bb-buck — Design Document

PCB-0010-A

hwde v1 pipeline

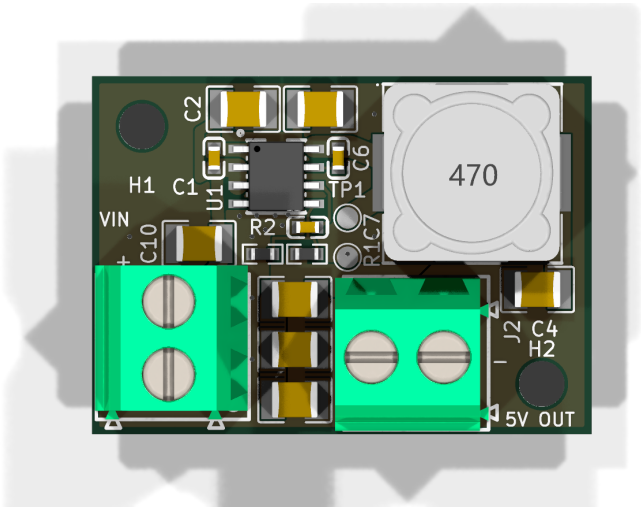
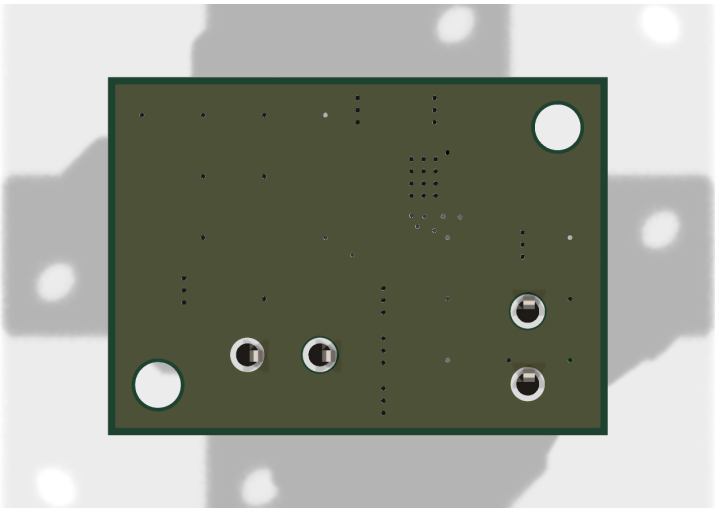
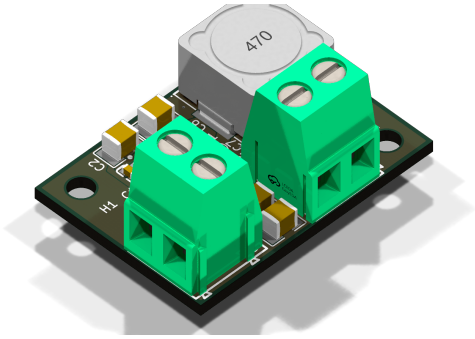
The in-pad array is 3 x 3 at 0.85 mm pitch, 0.30 mm drill / 0.60 mm pad, centred on the EP. The LMR33630 datasheet Sec 10.1.1 is imperative and specific: *"Use a minimum 4 x 3 array of 10-mil thermal vias to connect the PAD to the system ground plane heat sink. The vias must be

The 0.30 mm barrels partly recover the count: barrel-wall conductance scales roughly as n x d, so 9 x 0.30 = 2.70 against the datasheet's 12 x 0.254 = 3.05 - about 88 % of the minimum. Using the design's own 192 K/W-per-via figure, 9 vs 12 in parallel is 21.3 vs 16.0 K/W, ~5 K of extra junction rise at 0.92 W. That does not fail the part (Tj lands near 123 C against 150 C at 50 C ambient), but it eats most of the 2.06 C that `check_thermal` reports as margin - and `check_thermal` does not model the array at all, which is exactly why the constraints file made this review-enforced.

So a feature added purely for measurement convenience quadrupled the switch node's proximity to the gate-drive rail and nearly tripled it to the feedback node - the two nets `constraints.json` names as needing distance from /SW. The absolute coupling is small (tens of femtofarads; order 20 mV of per-cycle glitch on a 1 V reference through the FB node's own capacitance) and nothing here is illegal, but it is entirely avoidable: the U1.8 -> L1.1 corridor is 4.7 x 5.4 mm of existing /SW copper and a 1.5 mm pad fits inside it at roughly (44.97, 42.08) [18.9, 7.6], with TP2 following ~2.5 mm below. Deleting the stub also removes 2.5 mm of open-ended 1.52 mm track from the switch node.

JLCPCB's assembly guideline is >= 1 mm component-to-board-edge, and the depanel question matters more than the placement question: a 12.3 mm, 8 mm-tall part whose solder joints sit 0.5 mm from a V-scored edge is exposed to snap stress at depanelisation. Nothing else on the board is under 1 mm except the two terminals (intentionally, at 0.30 mm, openings at the edge) and C9 at 1.15 mm; C2/C3 are at 1.05 mm.

6. Both GND screw-terminal pins are flooded solid into full-board pours on both layers (plane) J1.2 at (31.670, 55.920), J2.2 at (51.310, 53.880). Both zones carry `(connect_pads yes (clearance 0.5))` - KiCad's *solid* pad connection. The `thermal_gap`/`thermal_bridge_width` values present in both zones are inert while `connect_pads` is `yes`.

Each of those pins is a 1.6 mm drill in a 2.4 mm pad, solidly tied to a 595.5 mm2 1 oz F.Cu pour on top and a 783.3 mm2 pour on the bottom - four solid plane connections to heat. requirements.md s7 explicitly allows the fallback path "hand-soldered after SMT", and that is where this bites: a normal iron will not get a plane-connected 1.6 mm barrel to reflow temperature reliably, and a cold joint on J2.2 is the 2 A return path. JLC's selective/wave process with preheat copes better, but the assembly route is not yet decided.

12. The GND void under L1 was never cut, and cutting it would break the 2-layer story (plane) `constraints.json _review_enforced (4)` requires "a GND void under the body" for L1. Measured over L1's 12.3 x 12.3 mm footprint: F.Cu GND covers 68.2 %, and over the core between the two pads it covers **99.5 %**; B.Cu GND covers 100 % of both.

13. The declared 6.5 mm M3 keepouts do not exist (plane) `_review_enforced (3)` calls for hand-added KiCad rule areas giving a 6.5 mm mask/copper keepout at each M3 hole, because `planes_gen` cannot void. The board has **zero** keepout zones; both GND pours run to 0.5 mm from the board edge and up to both NPTH barrels.

This is cheap to fix and it fits: a 3 x 4 array at the existing 0.85 mm pitch spans 1.70 x 2.55 mm inside a 2.50 x 3.50 mm pad, with 0.3 mm to every pad edge. Add one row (3 vias). See also warning 4 - adding vias makes the stencil question sharper, so fix the two together.

Fix: switch both GND zones to thermal-relief pad connection for through-hole pads (`connect_pads thru_hole_only` with the existing 0.5 mm gap / 0.5 mm spoke), or add per-pad thermal relief on J1.2 and J2.2 only. The SMD pads should stay solid.
